## DEVIATION REQUEST AND DECISION FORM

Project Name :	Ponderosa at Lorson Ranch Filing No. 3
Schedule No.(s) :	5514301027
Legal Description :	TR L PONDEROSA AT LORSON RANCH FIL NO 1

The deviation request is to allow application of the sight distance criteria from Table 2-35 *Entering Sight Distance for Driveways (Access Design)* in lieu of Table 2-21 Intersection Sight Distance to the Winter Gem Grove (proposed private street) connections to Old Glory Drive (a public street). Figure 3 from the TIS report is attached as an exhibit.

Figure 3

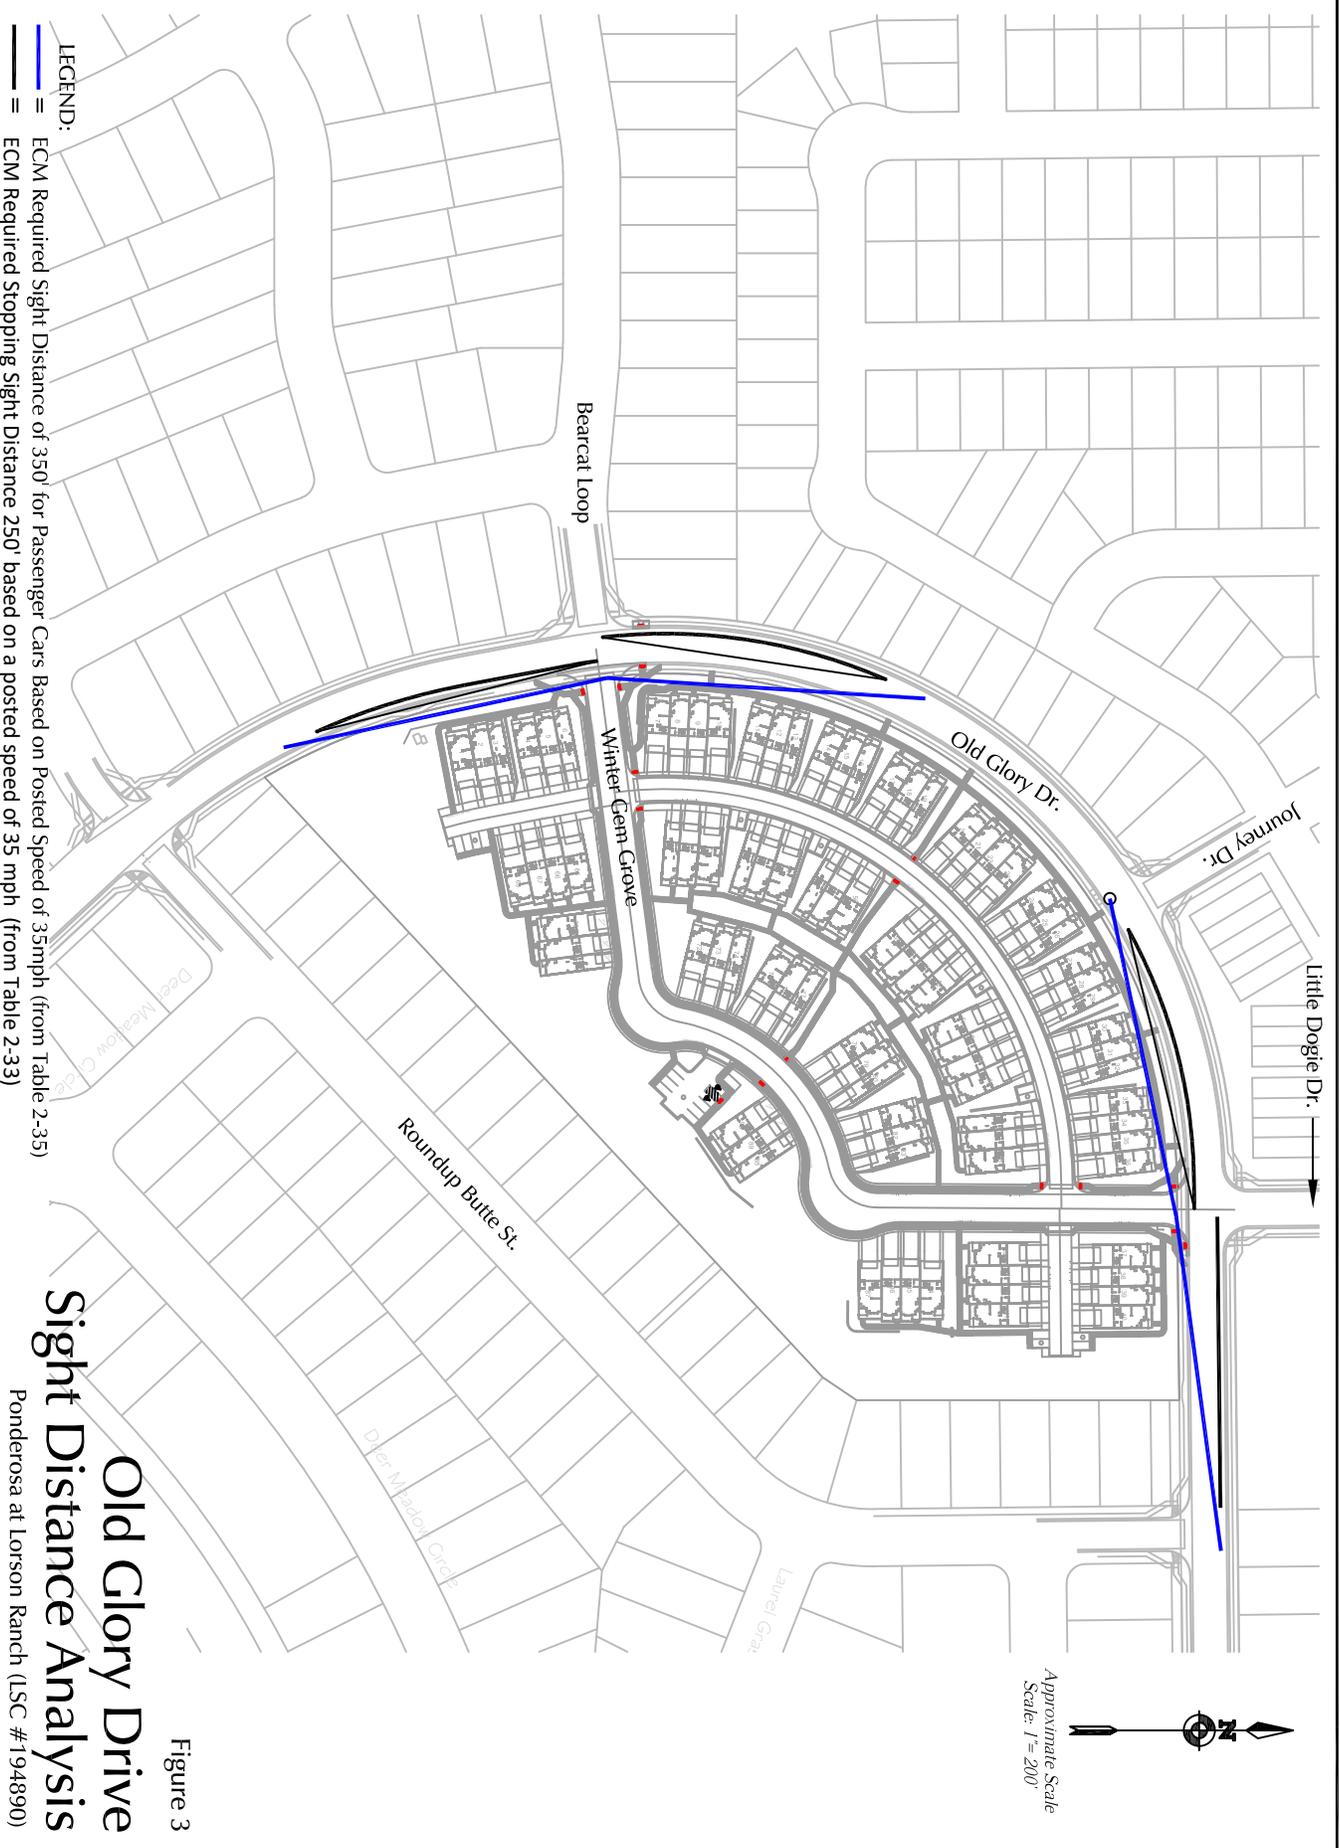
Per Table 2-21 the required intersection sight distance for roadway with a design speed of 40 miles per hour is 445 feet. Per Table 2-35 the required entering sight distance for passenger cars on a two-lane roadway with a posted speed limit of 35 miles per hour is 350 feet. This is about 95 feet less than the distance required by Table 2-21.

Use of the criteria contained in Table 2-21 is problematic due to the constraints of this "left over" parcel on the inside of a curve with no other street connections – conforming to the sight lines per Table 2-35 are acceptable (and would meet CDOT criteria) and use of sight lines per Table 2-21 would impact the site and the site development/layout significantly.

The available sight distance at the proposed access points would meet the requirements for driveways per Table 2-35 of the ECM and would meet the entering sight distance criteria from the State Highway Access Code. Old Glory Drive/Winter Gem (private) (southwest access and northeast access) will not be *"intersections where one public road meets a second public road"* for which ECM section 2.3.6.G applies.

Additionally, keeping landscaping low behind lots 7-16 and 27-36 (between the back of the sidewalk and the closest individual lot line will provide some additional sight distance beyond that required in Table 2-35.

This request has been determined to have met the criteria for approval. A deviation from Section 2.3.6.G of the ECM is hereby granted based on the justification provided.
